**Re: 648, 670, 686, & 690 Pacific Street, and 171 Henry Street**  
**ZB 221-29 – Zoning Board Comments**

In response to comments and requested supplemental information during the hearing on 1/24/22, we are submitting the following materials as described below:

**SPL-1.0**

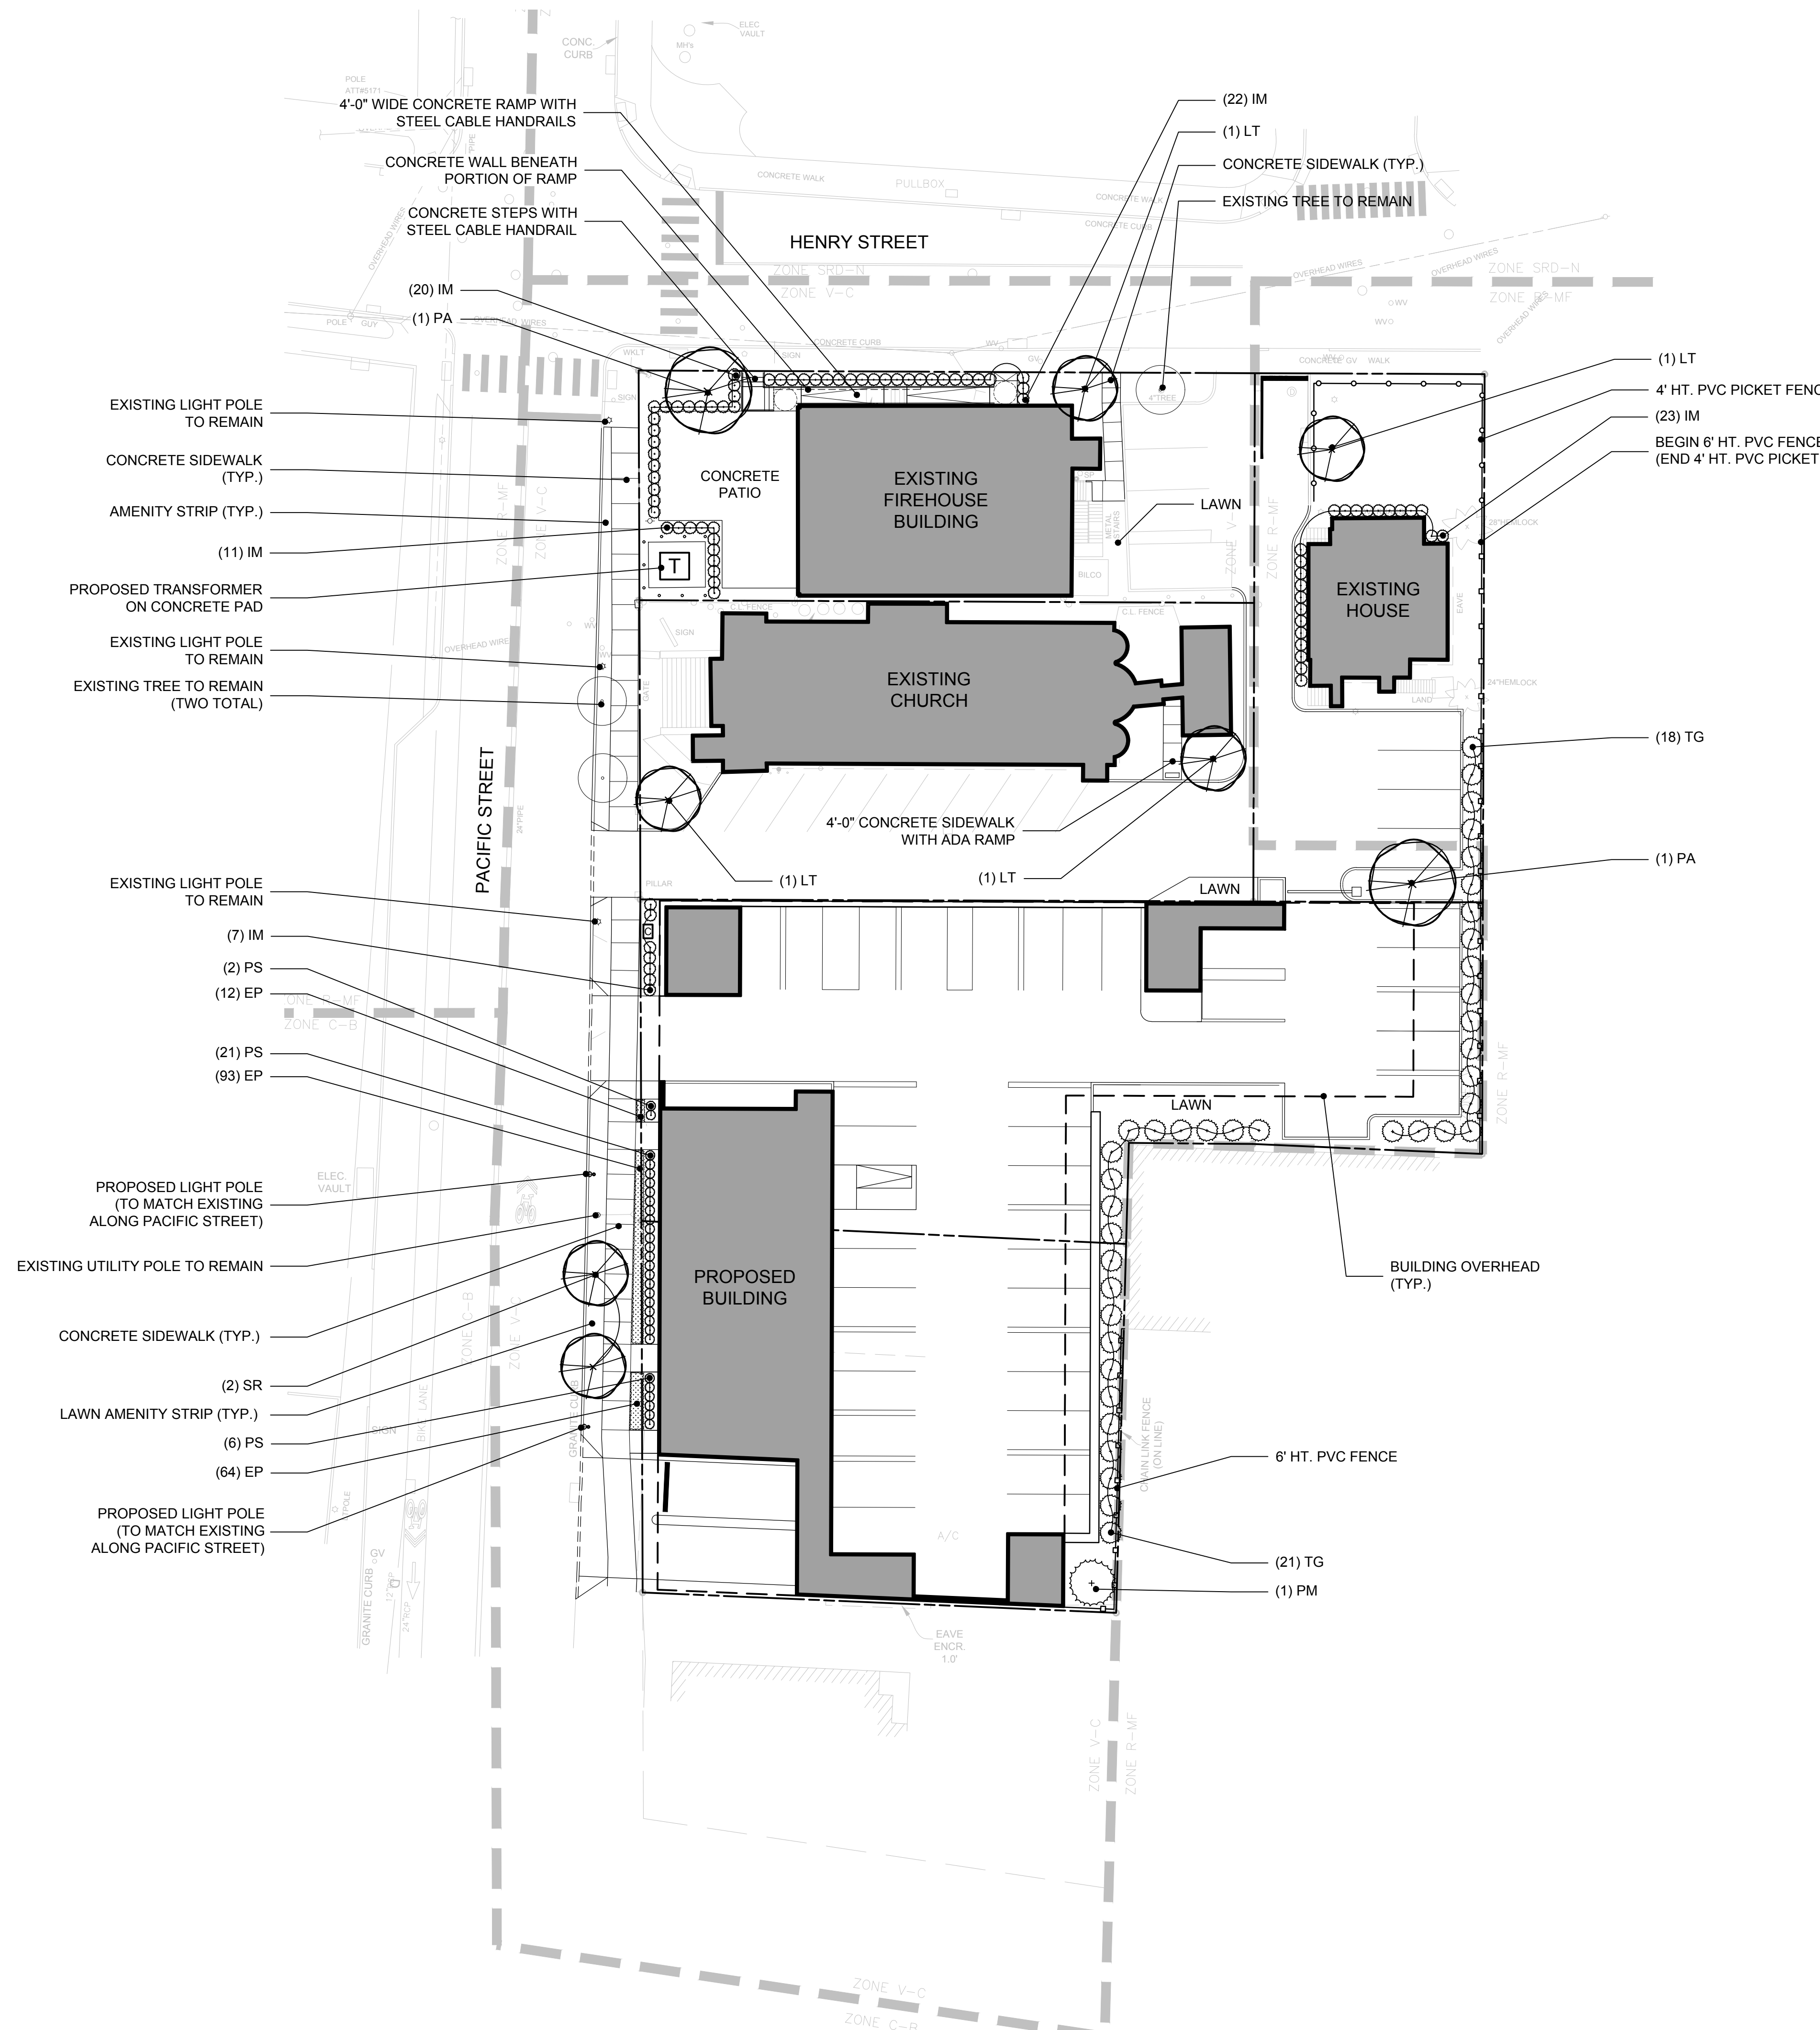
Landscaping plans have been updated to reflect 2 proposed street trees along the proposed building frontage, as well as two existing trees to remain in front of the church. The remainder of the street tree requirements will be satisfied through a fee to be calculated by staff based on the latest plans. **See landscaping sheets SPL-1.0 and SPL-2.0.**

The landscaping plans have been updated to provide a total of seven (7) new trees to replace the 7 being removed as part of the construction. **See landscaping sheets SPL-1.0 and SPL-2.0.** There are also 3 Elm trees proposed as part of the rooftop landscaping (SPL-1.1).

SPL-1.1

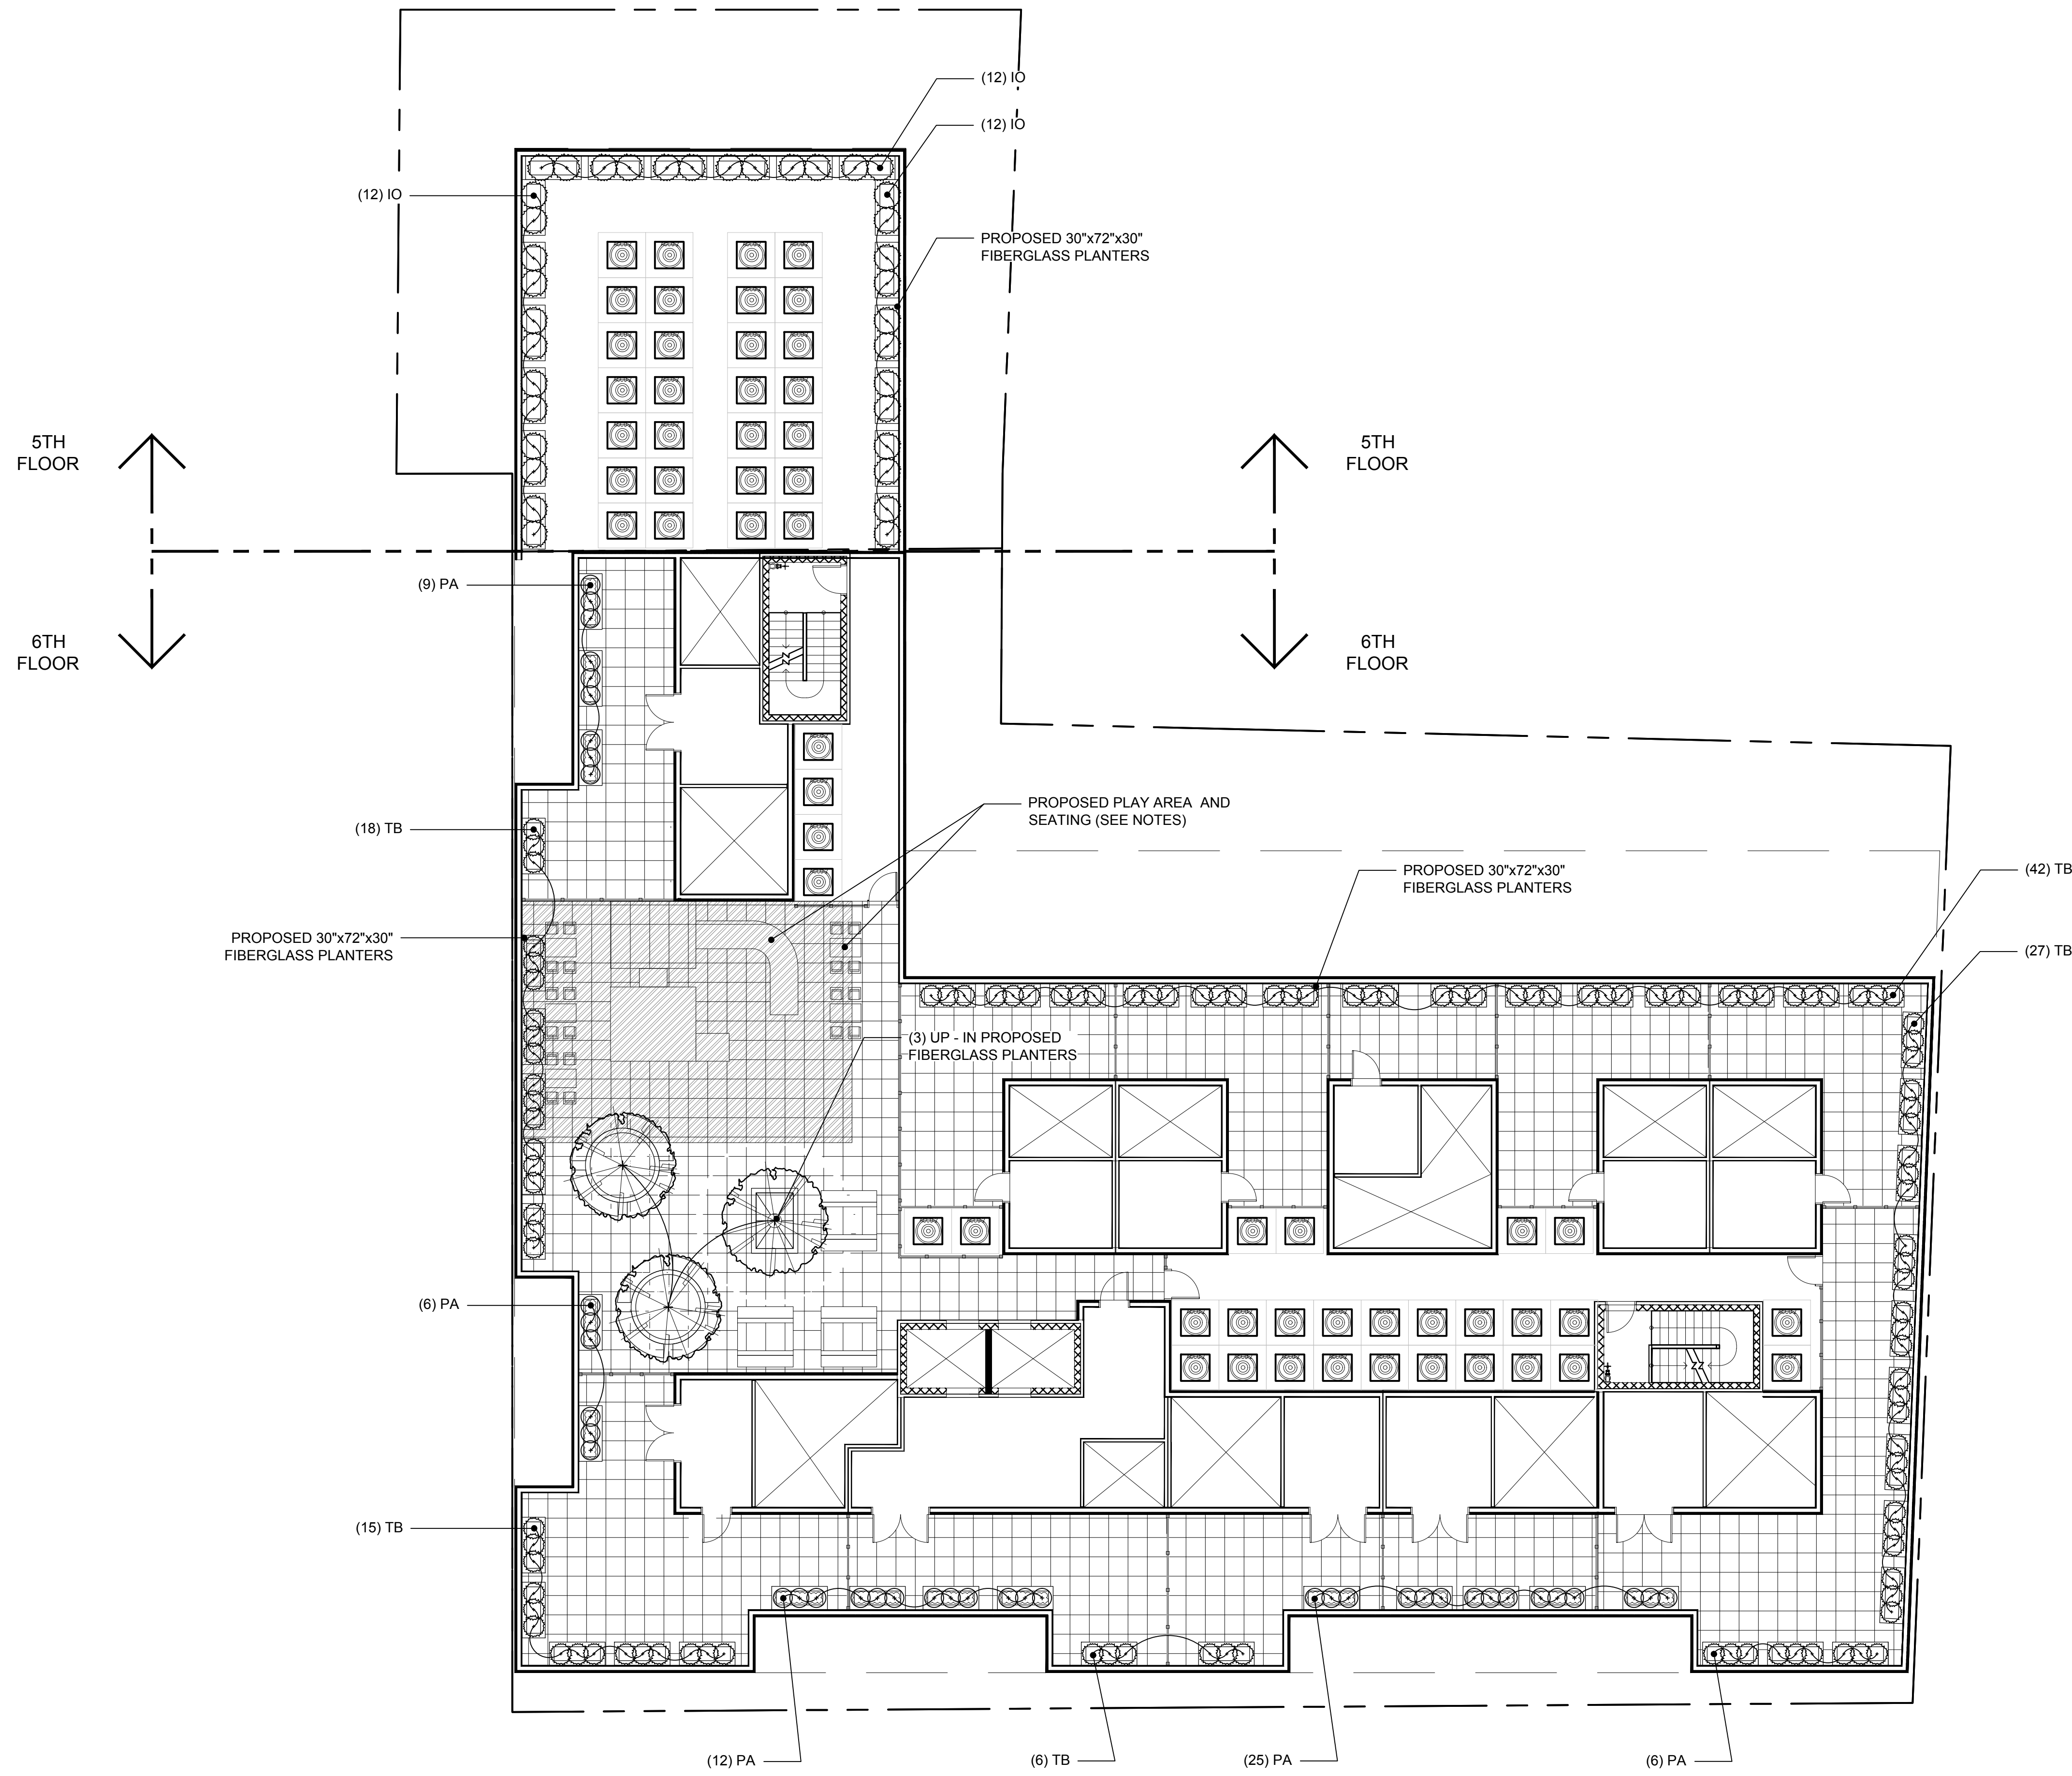
The previous note stating that planters on private balconies are for “illustration purposes only” has been removed. All planters are proposed as shown. **See landscaping sheet SPL-1.1.**
